**Re: Country Club Plaza – Commercial Building 1
1718 Central Ave., SW
Certificate of Occupancy – Transportation Development
Engineer's/Architect's Stamp dated 3-28-14 (J13-D010)
Certification dated 6-10-15**

Project Title: Country Club Plaza – Commercial Building 1 Building Permit #: T201492581 City Drainage #: _____
DRB#: _____ EPC#: _____ Work Order#: _____
Legal Description: Lot 4 of Country Club Plaza Subdivision
City Address: 1718 Central Avenue SW., Albuquerque, NM. 87104

Re: **Permanent Certificate of Occupancy for
Country Club Plaza – Commercial Building 1
Address: 1718 Central Avenue SW., Albuquerque, NM. 87104**

Douglas Heller, AIA
Attachment: Approved EPC/DRB Site Development Plan for Building Permit (with redlines)

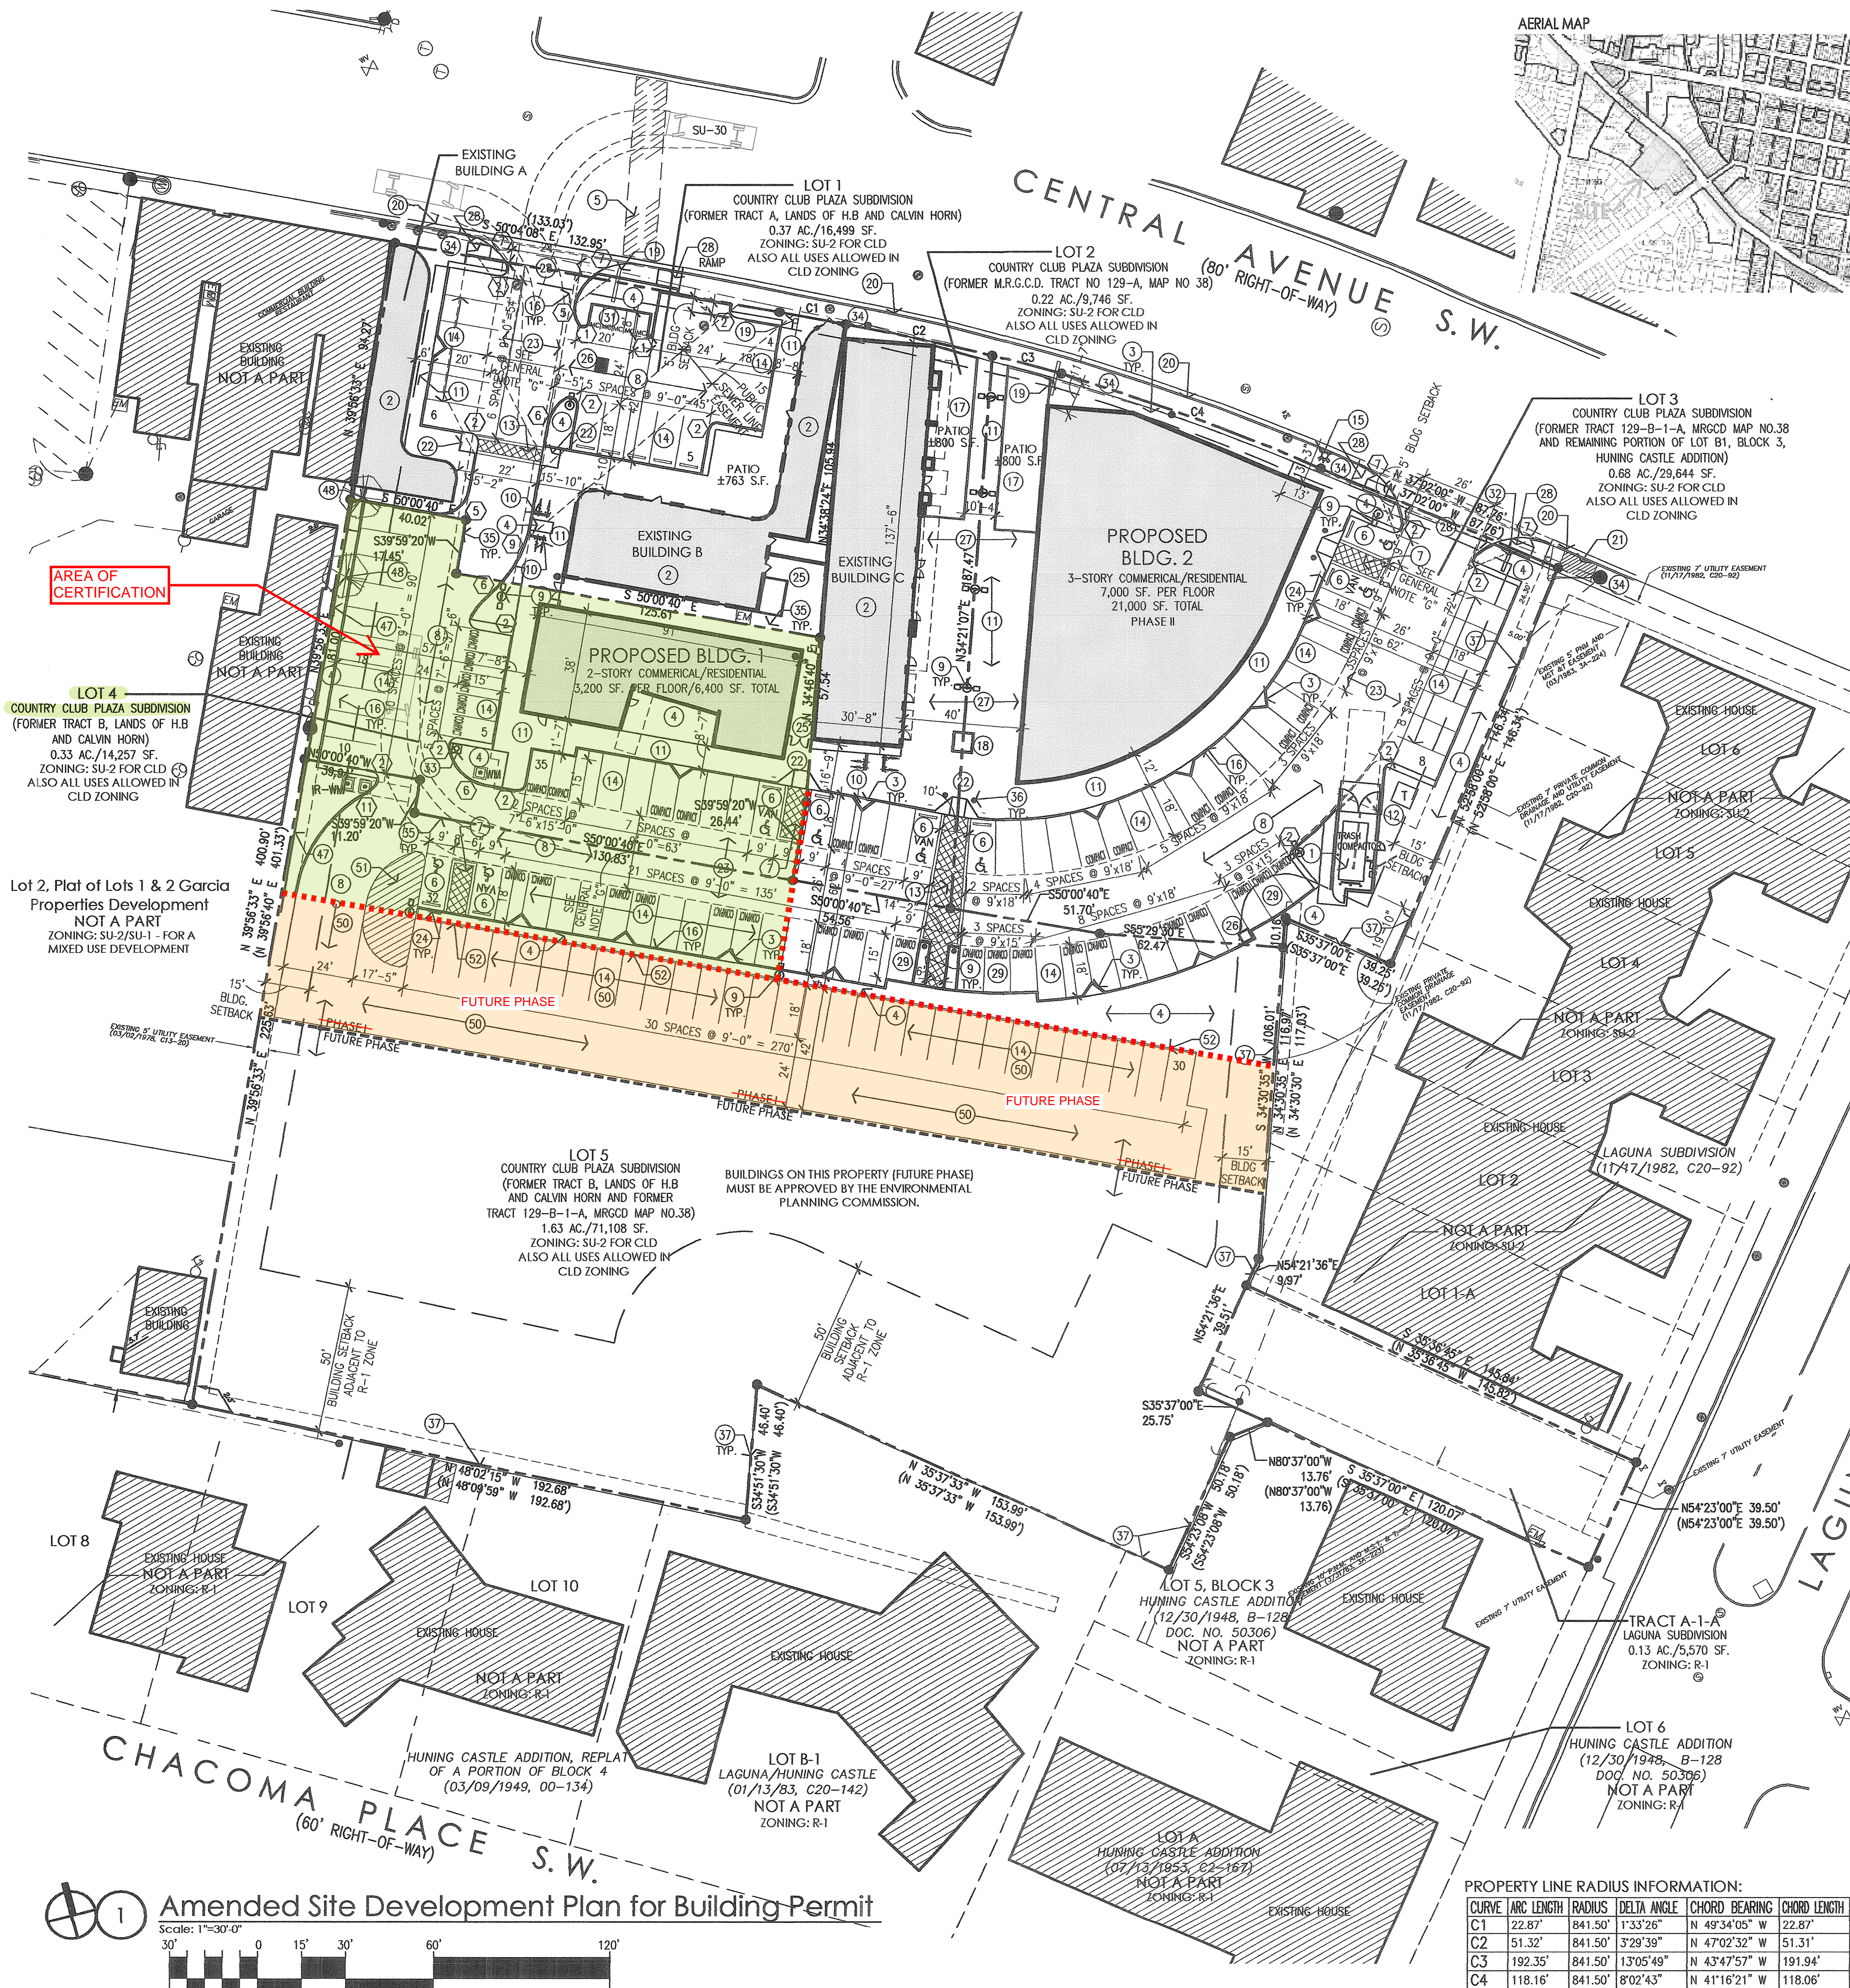
I, Douglas Heller, NMRA of Mullen Heller Architecture P.C., hereby certify that this project is in substantial compliance with and in accordance with the design intent of Approved EPC/DRB Site Development Plan approved October 10, 2013 (Project #1004677). The attached Site Development Plan also shows "redlined" the revised phase line on the south side parking of Building One (1) on Lot 4 of Country Club Plaza Subdivision.

This certification pertains only to Building One (1) of this development, as approved by the EPC/DRB and as "redlined" on attached Site Development Plan for Building Permit. I further certify that I have personally visited the project site on June 10, 2015 and have determined by visual inspection that the survey data provided is representative of actual site conditions and is true and correct to the best of my knowledge and belief. This certification is submitted in support of a request for Engineer's Certification (DRB Site Plan) for Permanent Certificate of Occupancy.
